northern beaches council PLANS APPROVED BY THE LAND AND ENVIRONMENT COURT OF NSW PROCEEDINGS NO: 2022/374407 DATED: 16 June 2023

16-18 RALSTON AVE BELROSE NSW 2085

SENIORS HOUSING

DEMOLITION OF EXISTING STRUCTURE DEVELOPMENT OF 16 SENIORS HOUSING UNITS, ASSOCIATED BASEMENT PARKING & LANDSCAPE WORKS

DA 1001 D

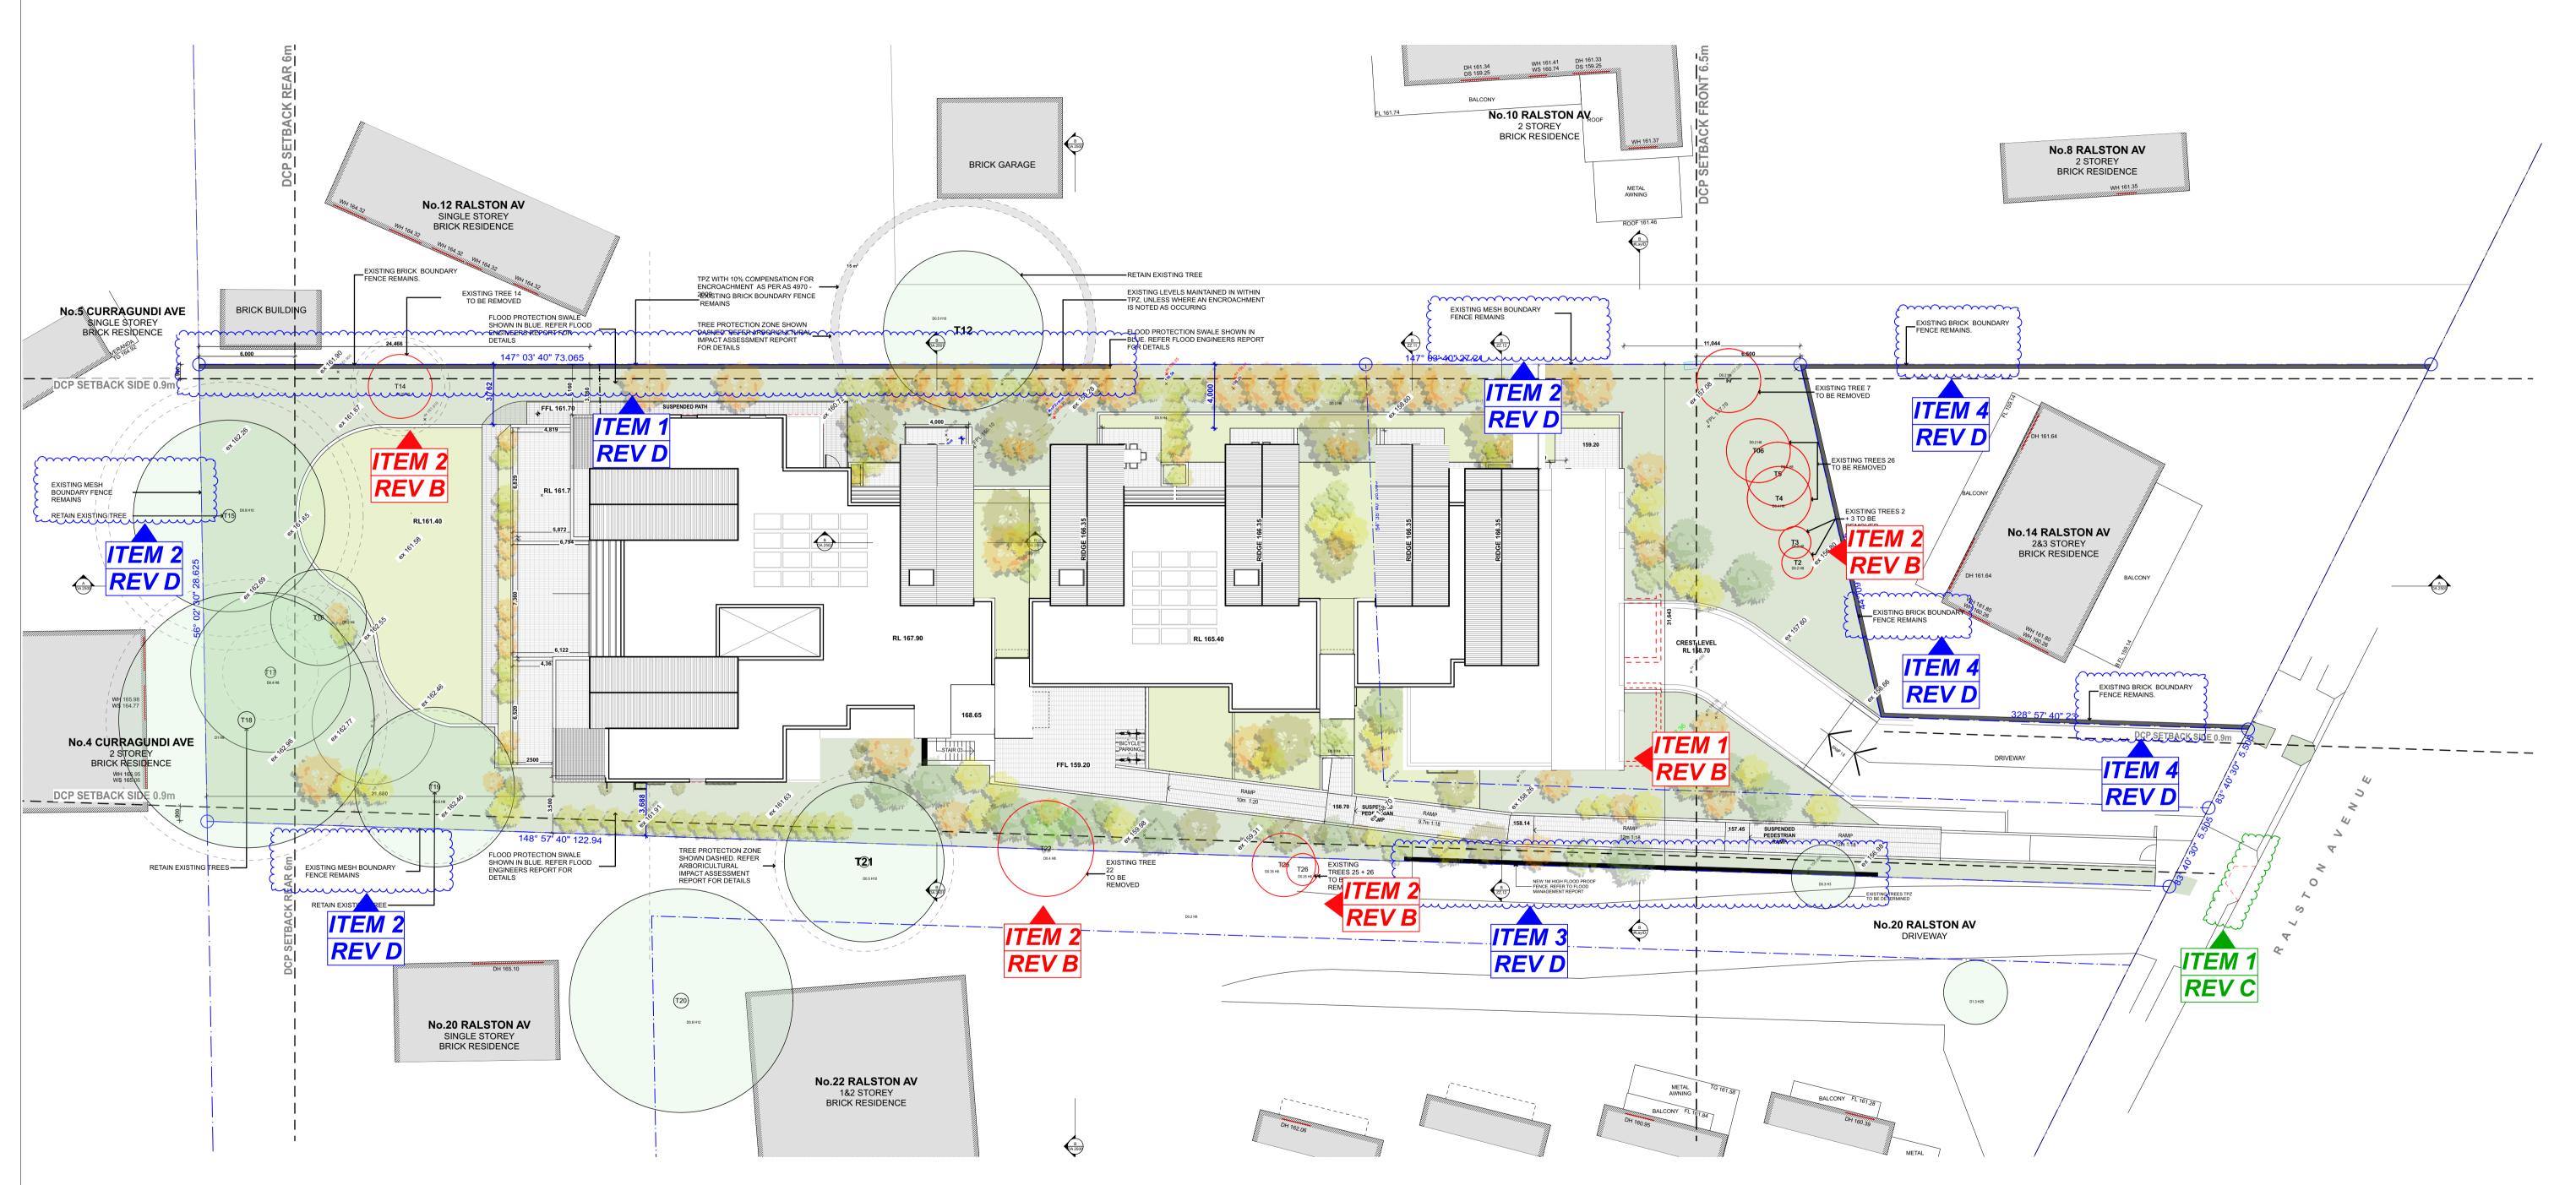
ITEM 2: Existing mesh boundary fences

ITEM 3: New flood management barrier to Western boundary added

ITEM 4: existing brick boundary fence to No. 14 Ralston Ave noted

ITEM 1: Existing Eastern brick fence retained ITEM 1: Removal of pram ramps at frontage of

ITEM 1: Southern Roof updated to reflect amendments to ground floor plan. ITEM 2: Removal of existing site trees 2, 3, 4, 5, 6, 7, 14, 22, 25, 26

DA 2000 E

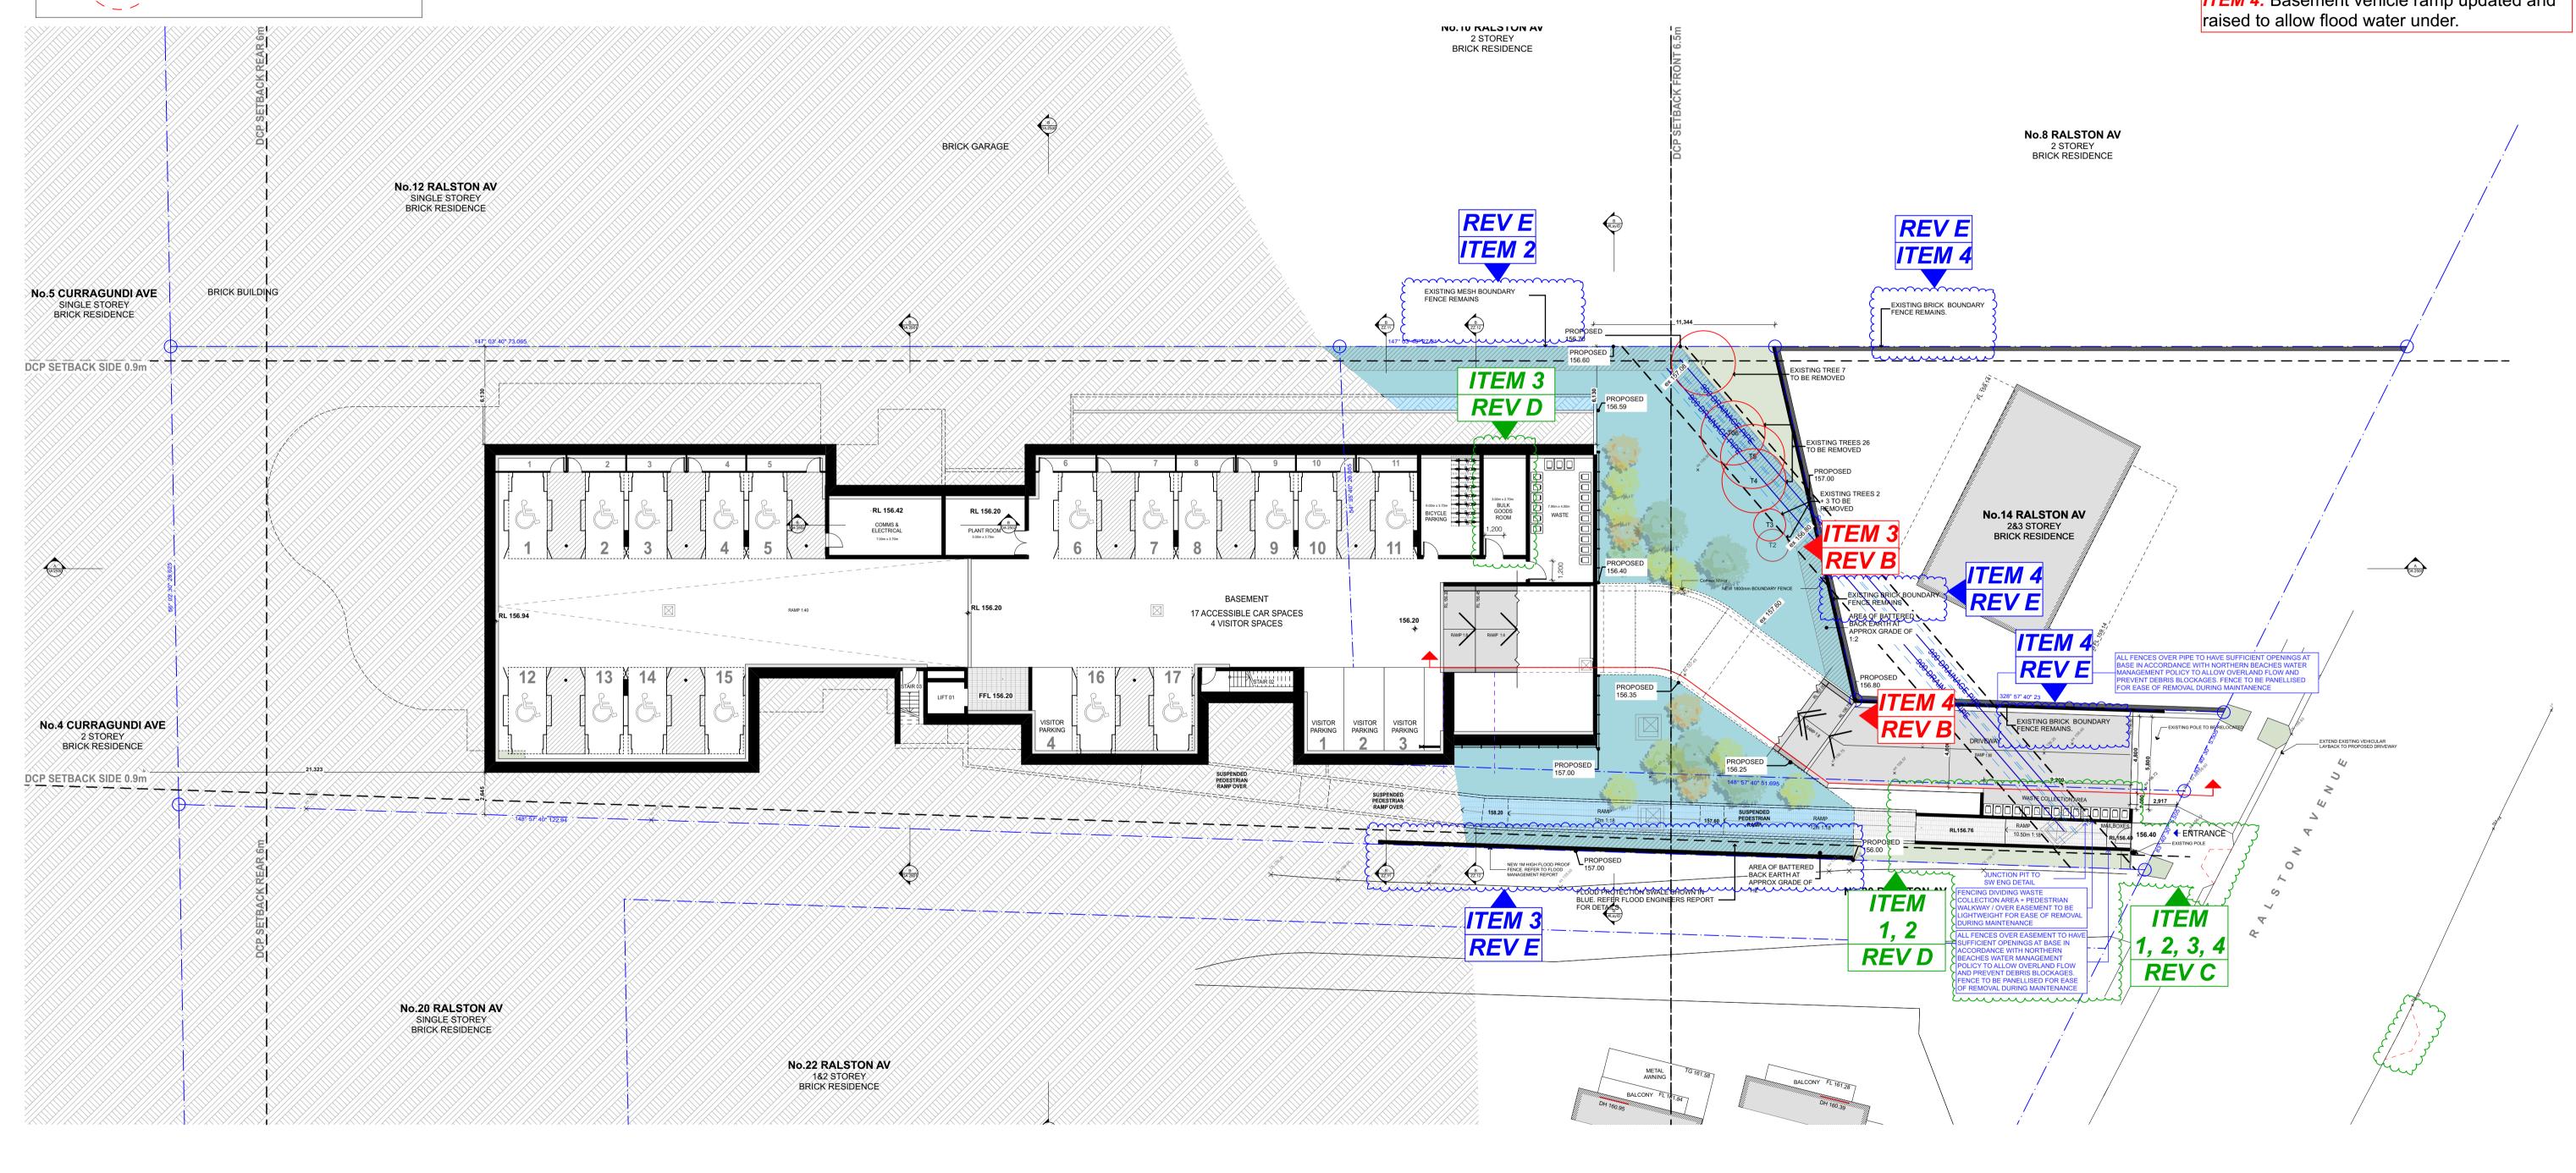
ITEM 1: Waste bin holding bay increased in size to allow 15x240L bins. ITEM 2: Access to bin holding bay updated with separate 1m wide entry. ITEM 3: 1200mm door added to bulky goods storage room.

ITEM 1: Removal of pram ramps at frontage of

ITEM 2: Mail box + garage collection area relocated.

ITEM 3: Fences over drainage pipe noted to be panellised with opening at base to allow for overland flow.

ITEM 4: updated stormwater details added to plans with inclusion of junction pit

ITEM 1: Flood protection swale shown in blue. Refer to flood engineers report for details. ITEM 2: Area along boundary to be battered back shown with hatch. At approx grade of 1:2. ITEM 3: Removal of existing site trees 2, 3, 4, 5, 6, 7, 22, 25, 26

ITEM 4: Basement vehicle ramp updated and

BLUE SHADE INDICATES EXTENT OF PROPOSED EXISTING EXTERNAL LEVELS BEING LOWERED TO PROVIDE FOR OVERLAND FLOODING. REFER TO FLOOD REPORT.

DA 2400 D

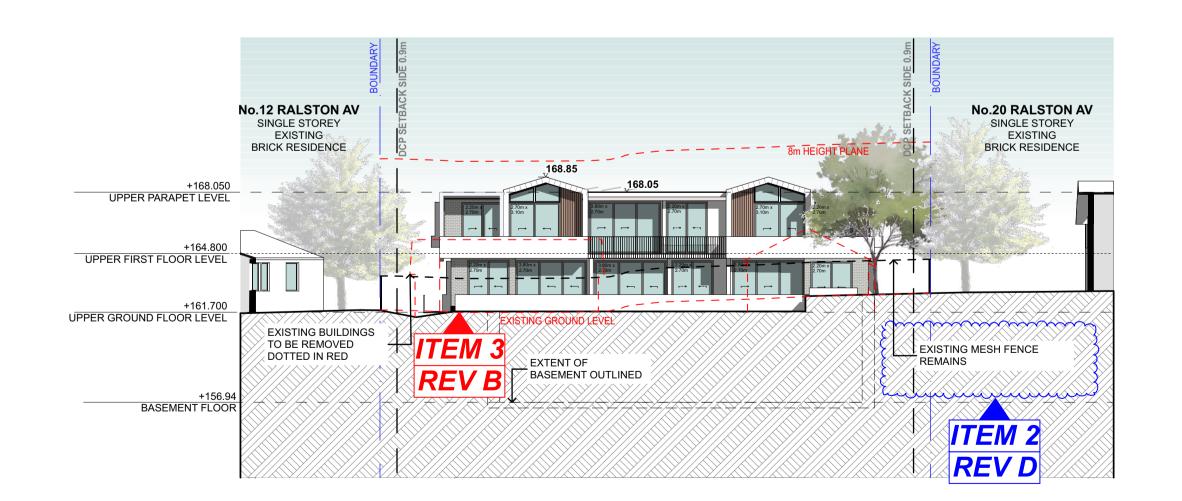
ITEM 1: N/A ITEM 2: Existing mesh boundary fences

ITEM 1: Privacy screens added to unit 12 eastern balcony.

ITEM 1: Basement vehicle entry ramp updated and raised to allow flood water under. ITEM 2: Unit 8 reconfigured from a double to

single bedroom unit. Approved structure to be

removed outlined in red.

ITEM 3: Levels along boundary updated. Refer to flood engineers report for details.

DA 2401 D Nominated Architect Brian Meyerson PROPOSED ELEVATIONS

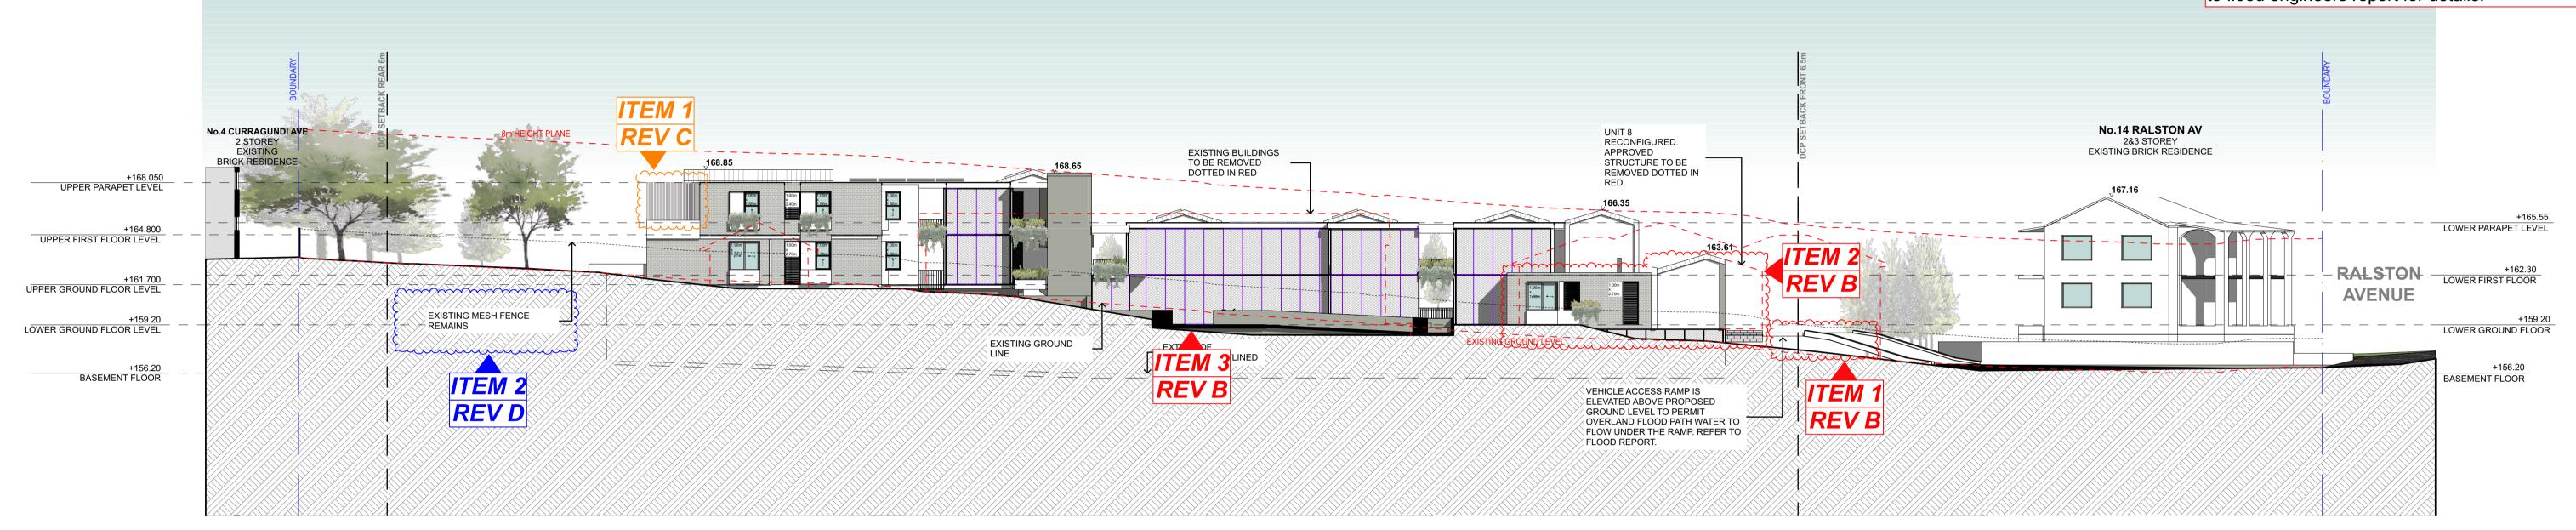
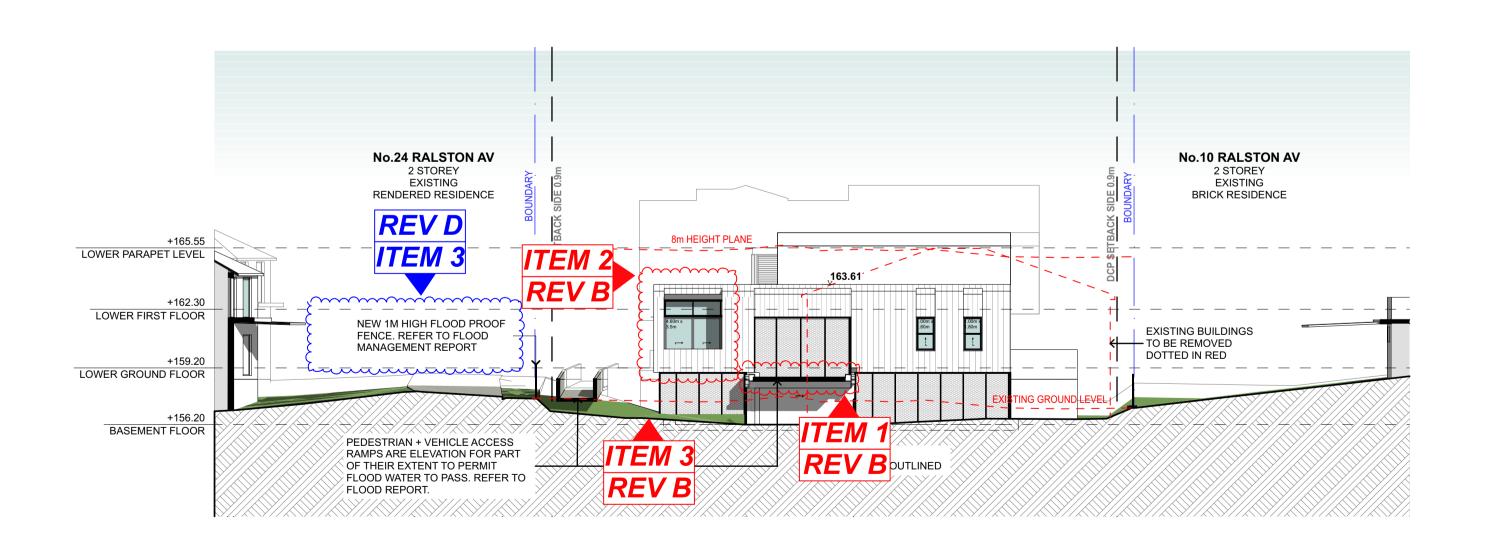
ITEM 2: Existing mesh boundary fences

ITEM 3: New flood management barrier to Western boundary added

ITEM 1: Privacy screens added to unit 10 western balcony.

ITEM 1: Basement vehicle entry ramp updated and raised to allow flood water under.

ITEM 2: Unit 8 reconfigured from a double to single bedroom unit. Unit 9 moved 2300mm north. Approved structure to be removed outlined in red.

ITEM 3: Levels along boundary updated. Refer to flood engineers report for details.

Nominated Architect Brian Meyerson SECTION A & B

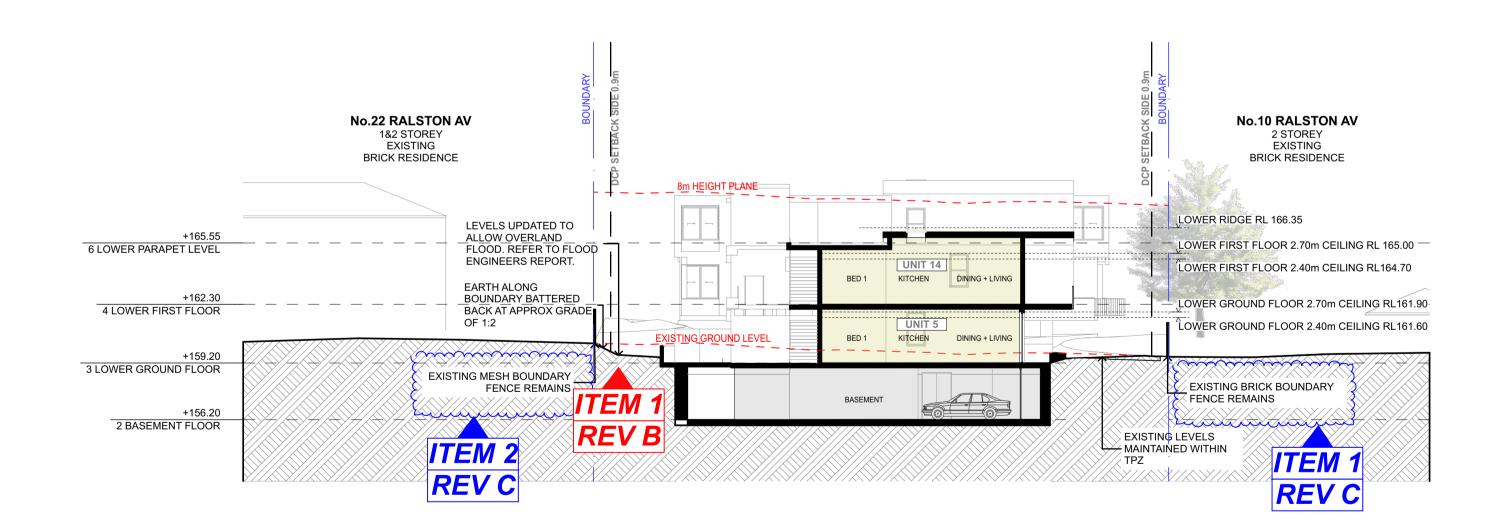
ITEM 1: Existing Eastern brick fence retained ITEM 2: Existing mesh boundary fences

ITEM 3: New flood management barrier to Western boundary added ITEM 4: Existing brick boundary fence to

No. 14 Ralston Ave noted

ITEM 1: Levels updated to allow overland flood. Area along boundary to be battered back at approx grade of 1:2. Refer to flood engineers report for details.
